## Re: Powerhouse Ultimo Revitalisation (SSD-67588459)

The Department of Education (the department) welcomes the opportunity to provide comments on the above application.

**Figure 2: Potential construction vehicle routes**

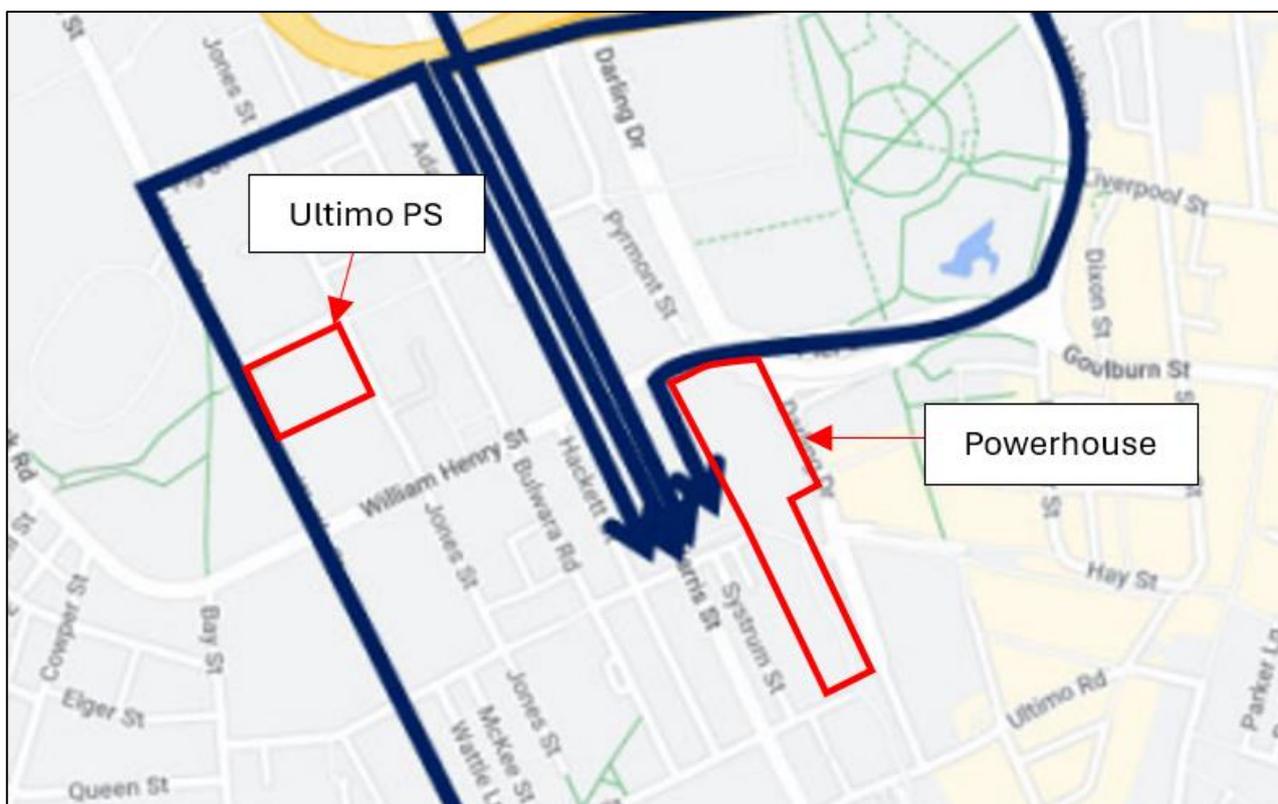
The department accepts that there will be an increase in heavy vehicle movements on the State Classified Roads adjacent and in close proximity to Ultimo Public School. Notwithstanding this, Wattle Street and Harris Street are one of the main walking routes to/from Ultimo Public School, which are currently proposed as part of the construction vehicle routes to/from the Ultimo Powerhouse Revitalisation site.

On this basis, it is recommended that a condition be imposed to ensure the movement of construction vehicles, including delivery vehicles, entering and exiting the development site, should be avoided during one hour before morning bell and one hour after afternoon bell times. This is to ensure the safety and accessibility of students and staff at Ultimo Public School who utilise the surrounding streets.
